## PLANNING TECHNICAL REVIEW COMMITTEE –AGENDA

Meeting Type: Regular Meeting  
Meeting Location: Council Chambers, City Hall, 288 Central Ave, Dover NH 03820  
Meeting Date: **Thursday, December 1, 2022**  
Meeting Time: **10:30 AM**

**Re: Application for Site Plan Review and Conditional Use Permits  
Durham Road, Dover  
Tax Map H, Lot 11  
Dover Project #P22-38  
P4952**

On behalf of Summit Land Development, Altus Engineering, Inc. (Altus) is pleased to re-submit the attached application material for Subdivision and Site Plan Review to construct the proposed medical office building on Durham Road, Tax map H, Lot 11. The applicant met with the Technical Review Committee (TRC) on June 2, 2022 and again on October 20, 2022 and received comments. As discussed at reviews, the applicant (McEneaney Survey Associates) has prepared a Subdivision application Subdivision Plan of Land for the property and has included it in this submittal. Below is a response to comments received from the various reviewers at the October 20, 2022 meeting.

# L1.0

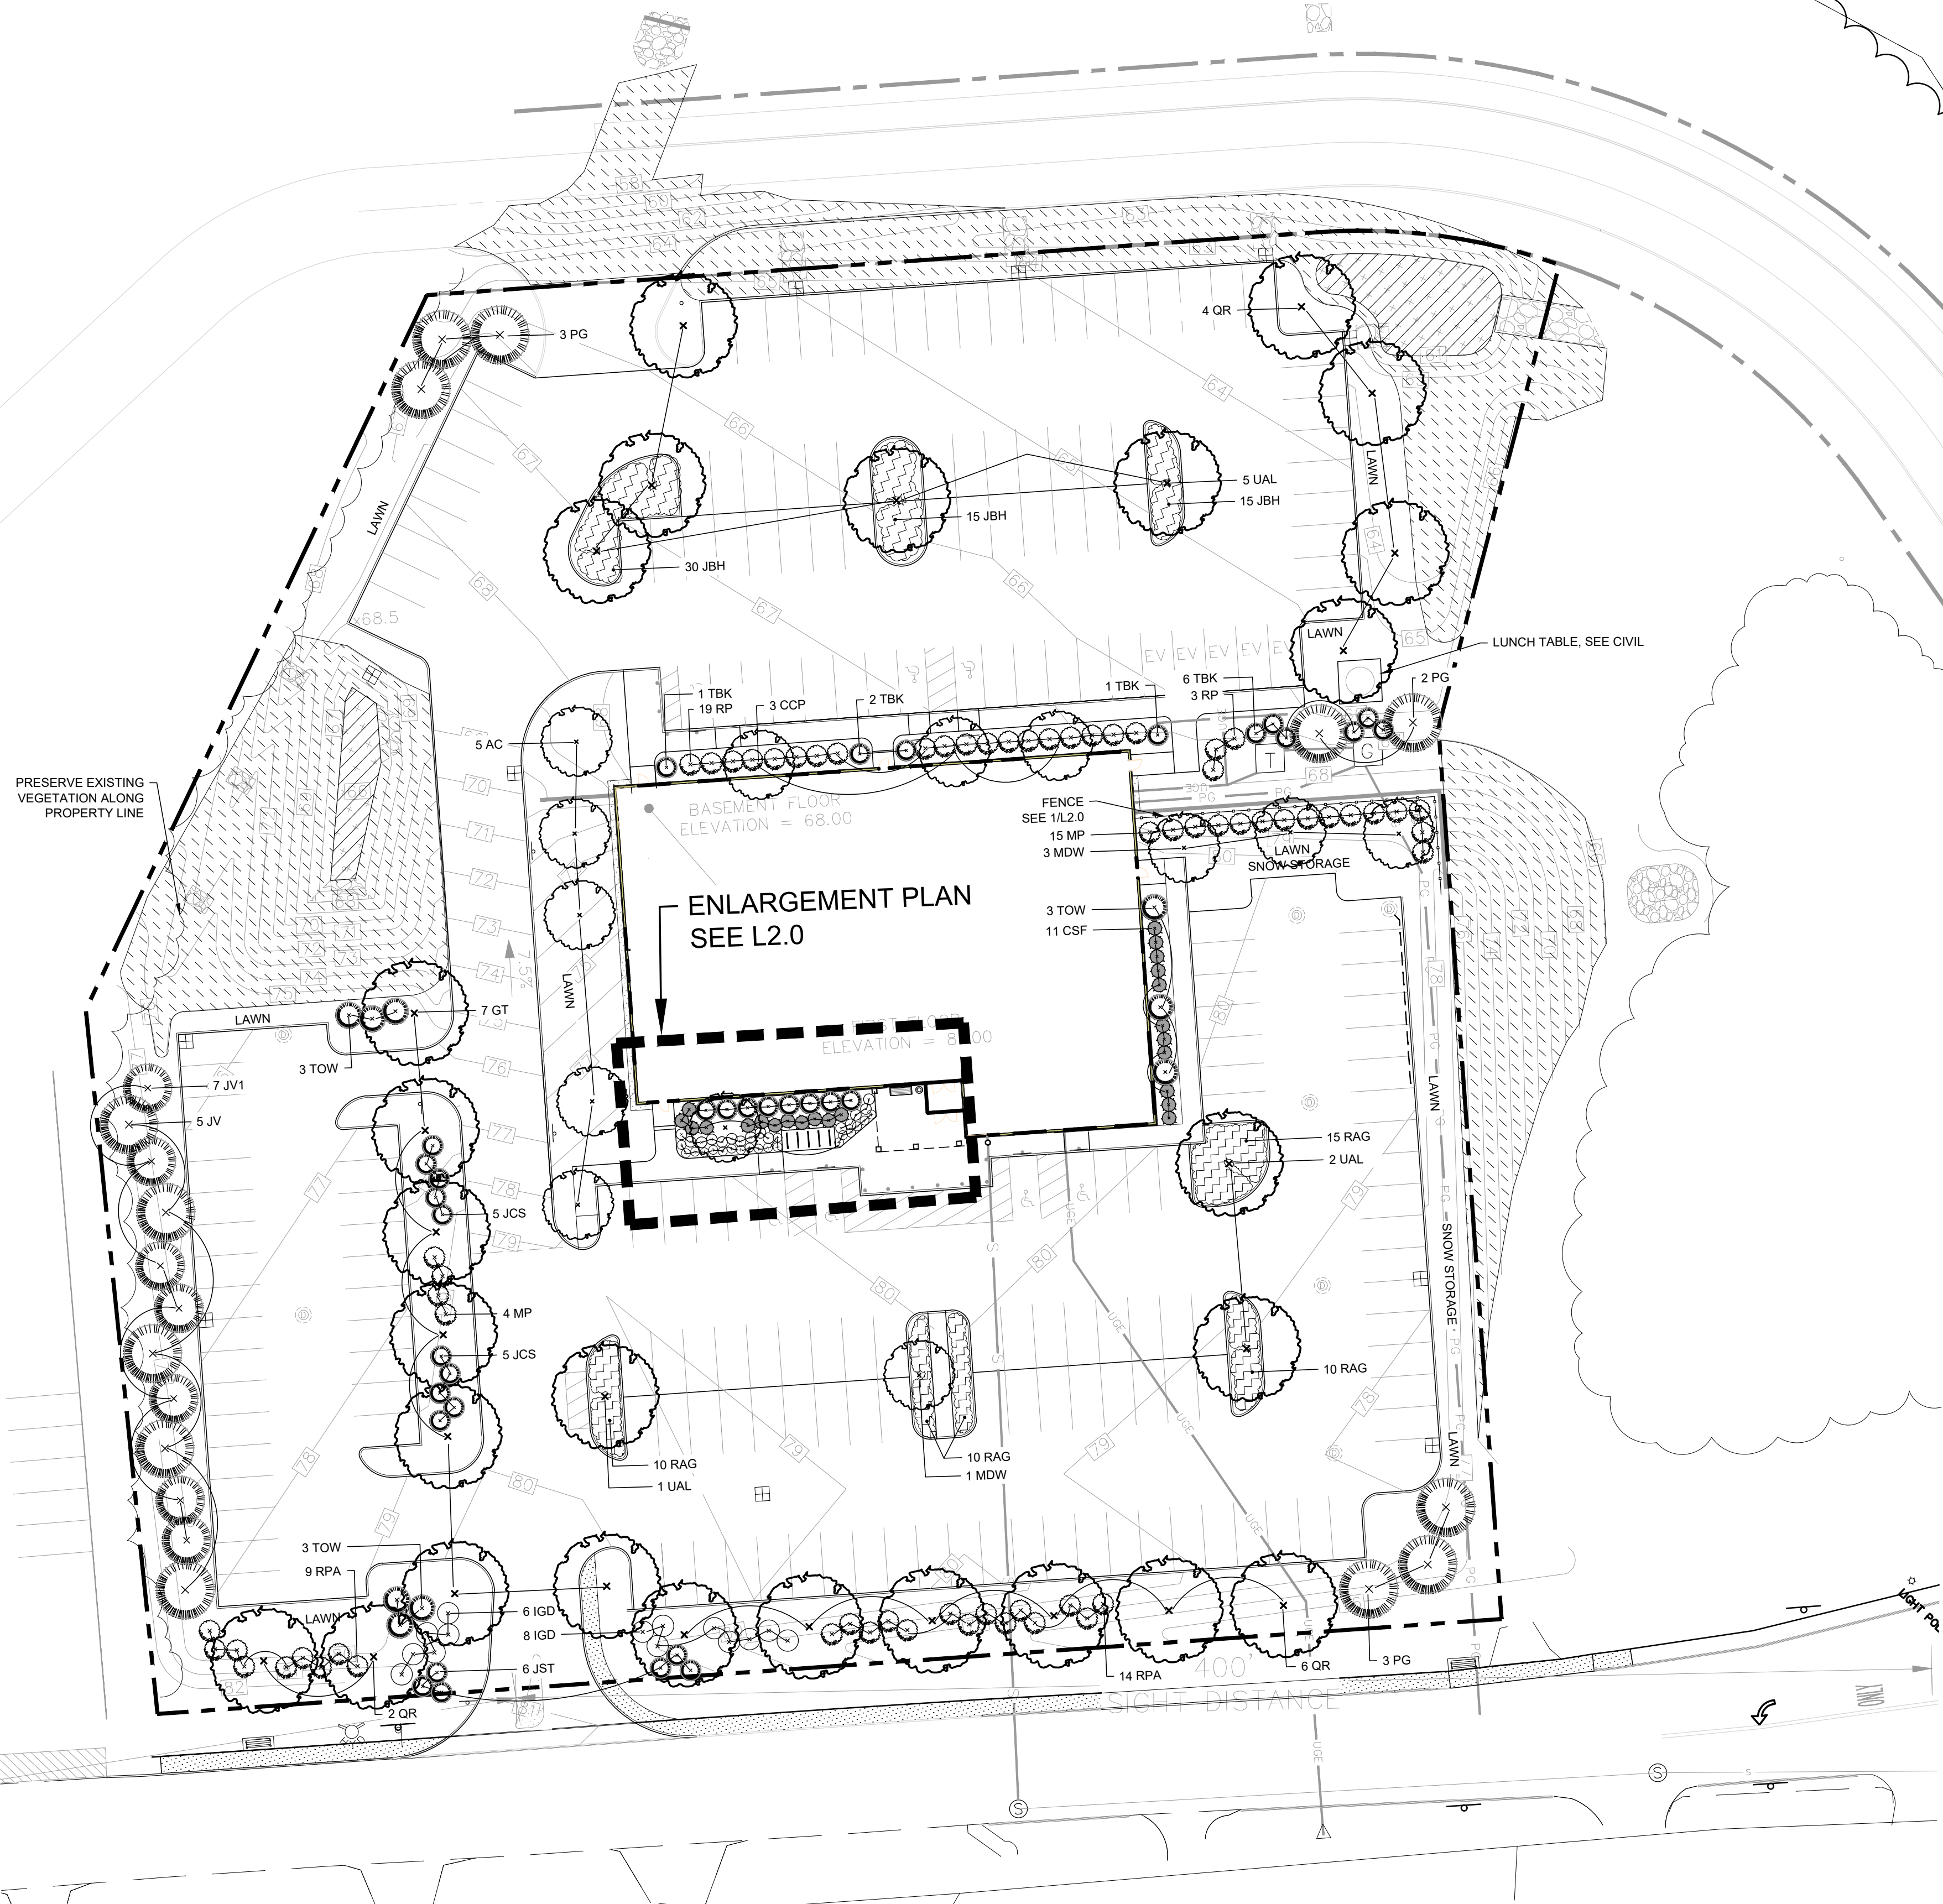
- The wood beam post has been revised to a 7 ft post, same depth used by NHDOT for wood beam guardrail.
- L1.0:Check landscaping conflicts with snow storage and lighting.

- The snow storage areas are revised.

AMBULANCE  
(WESTBOUND IN / OUT)

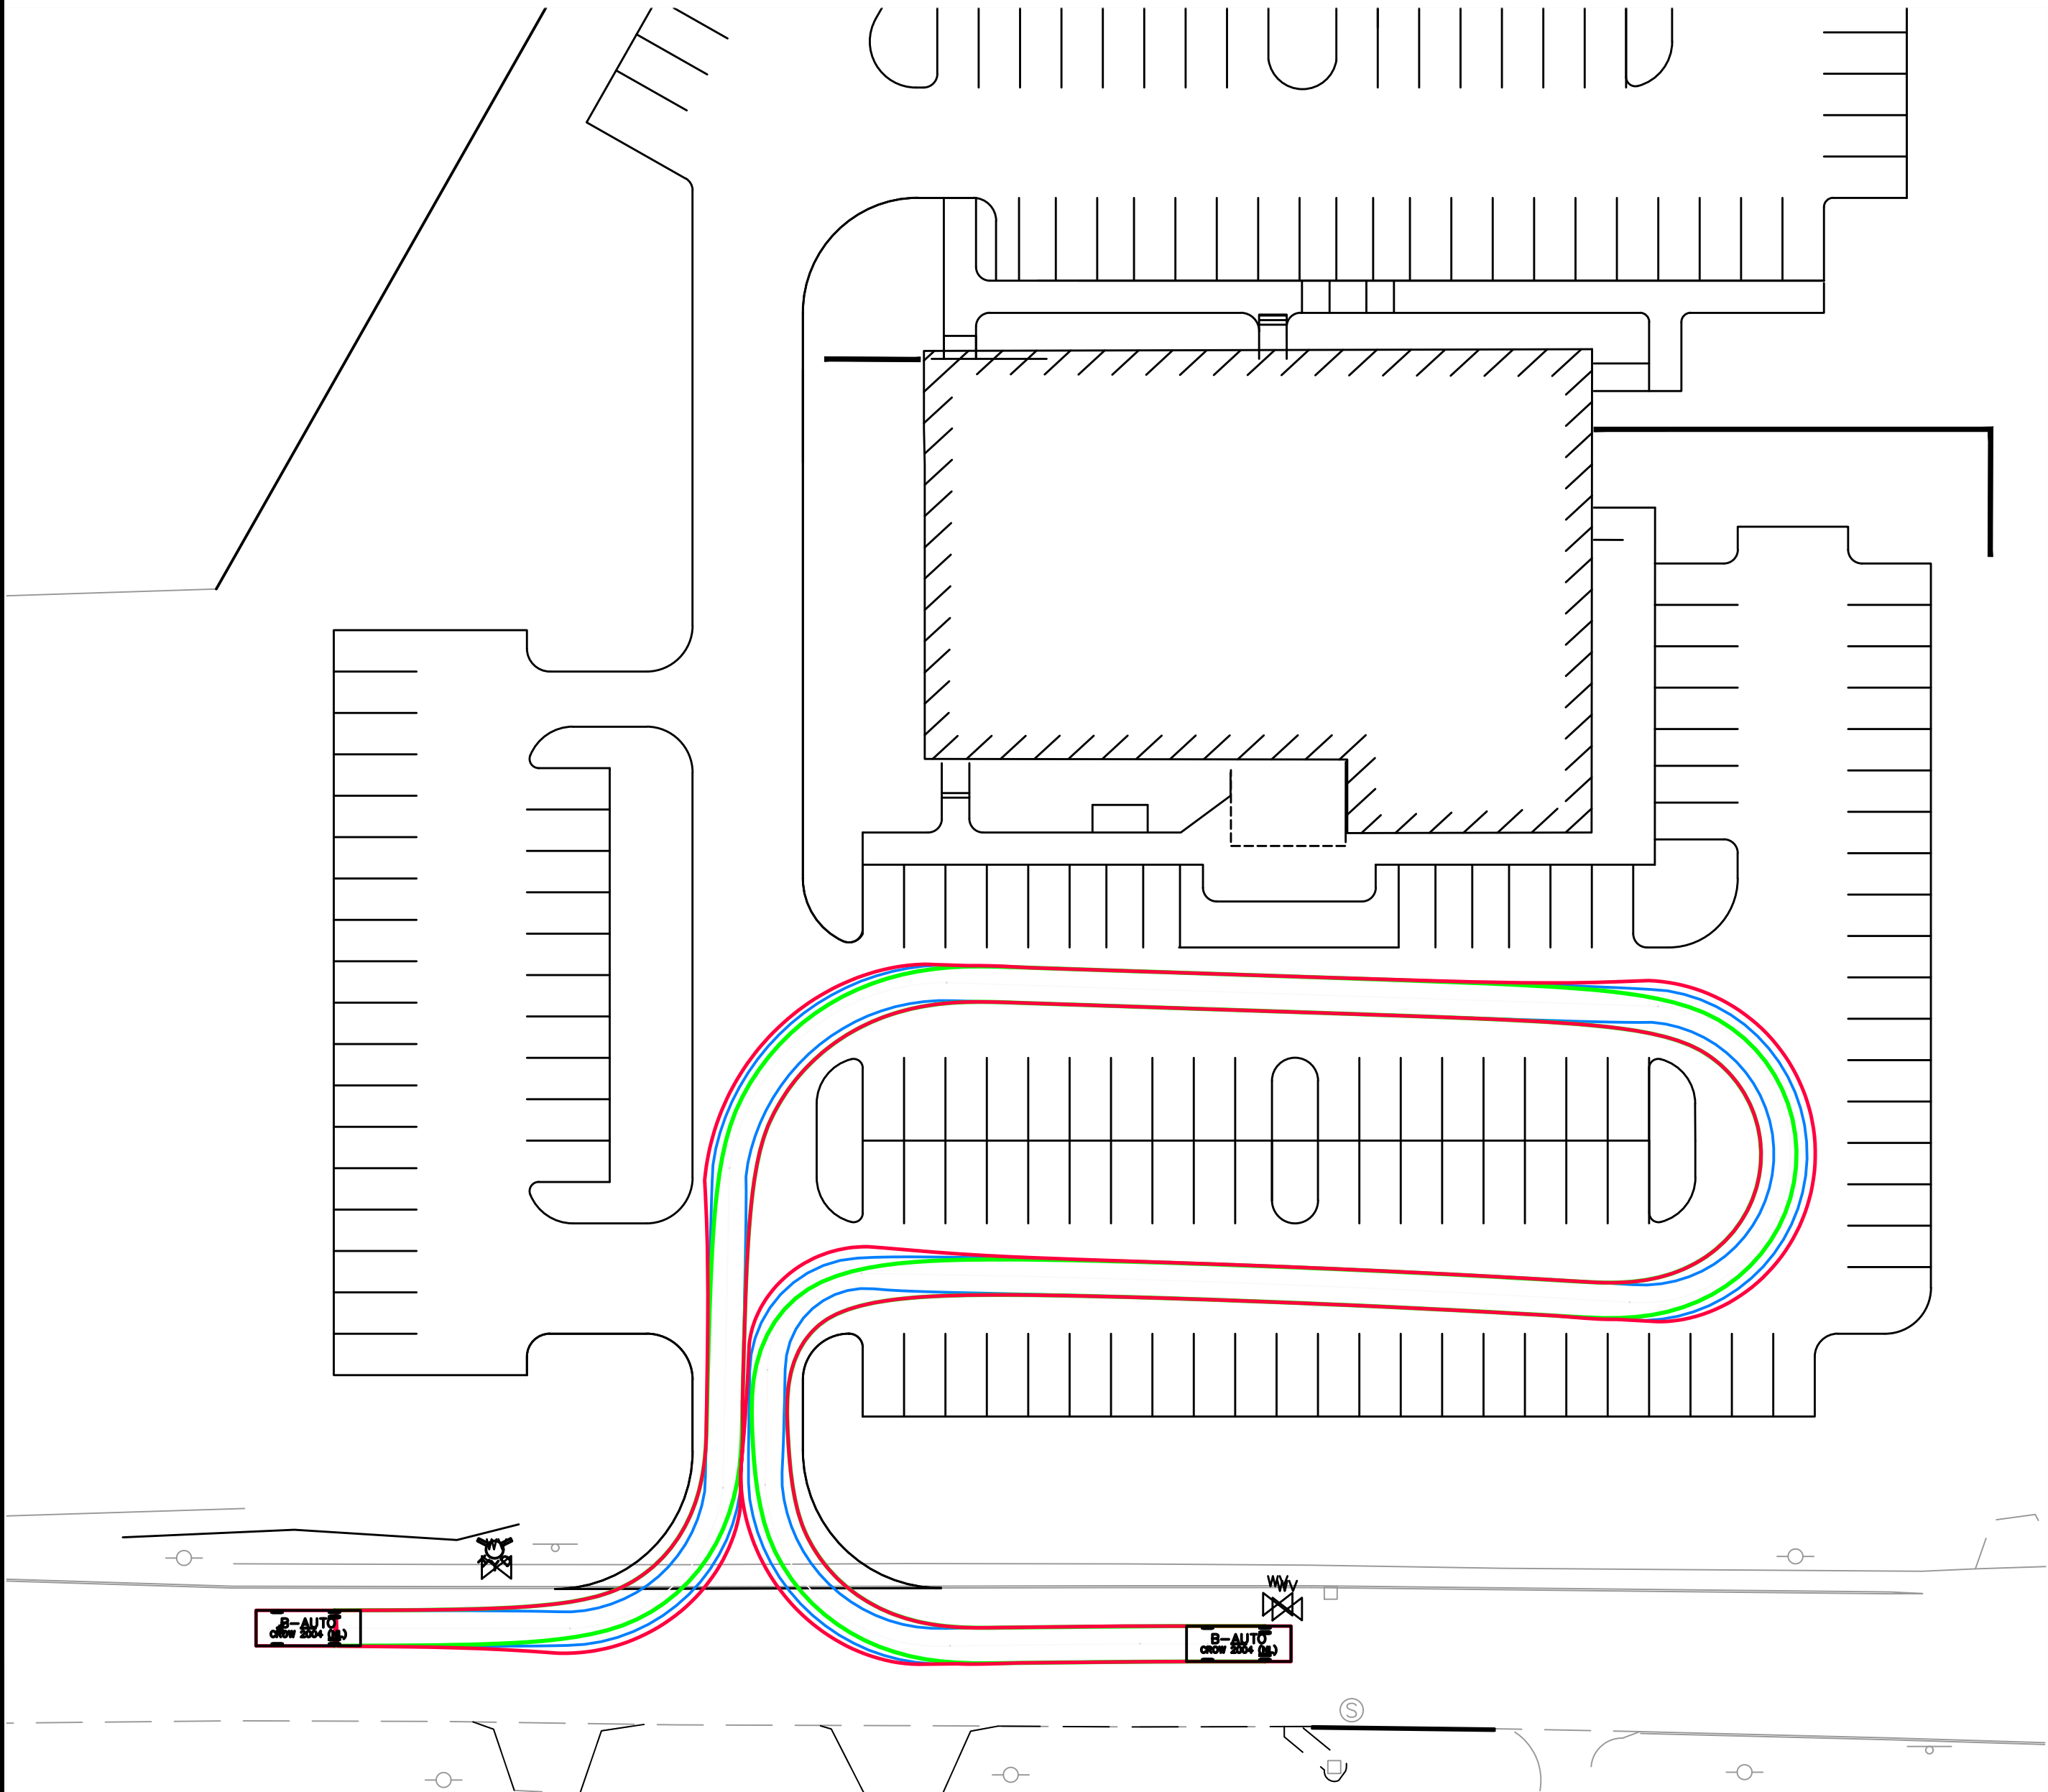
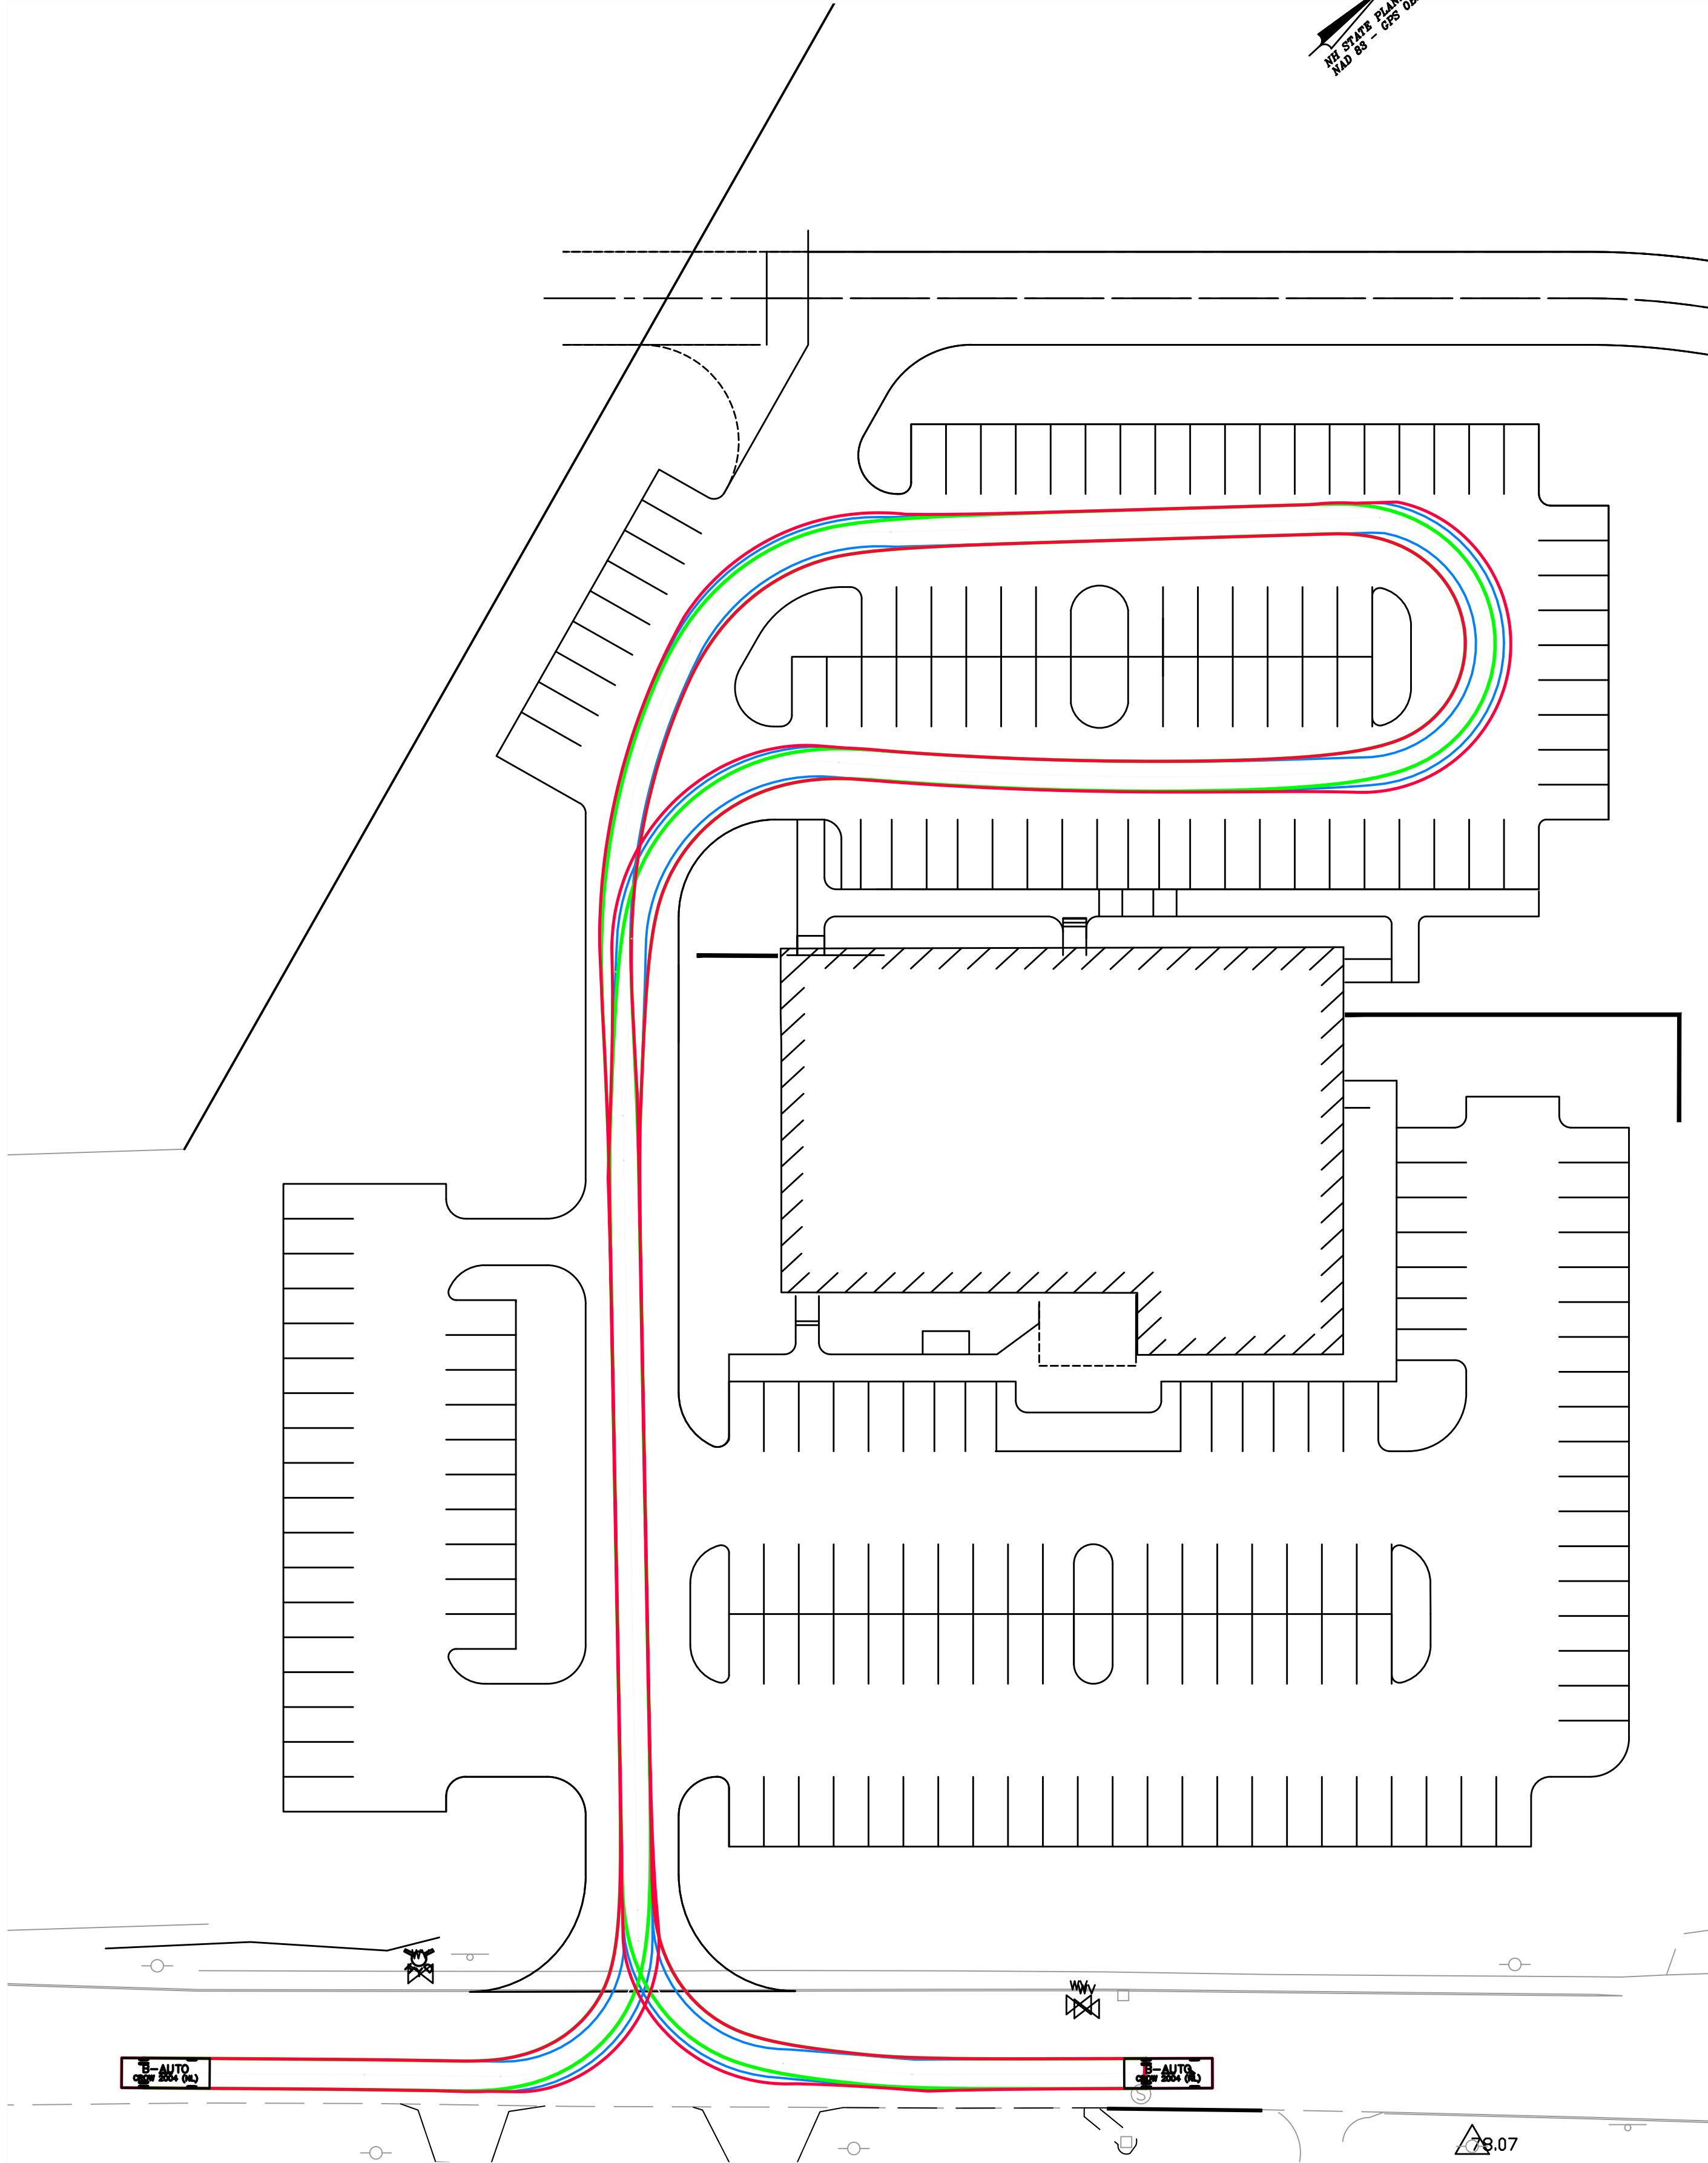
- Provide an ambulance turning template to the designated space in the front of the building and exiting the site.
  - The ambulance turning template is included in the plans.
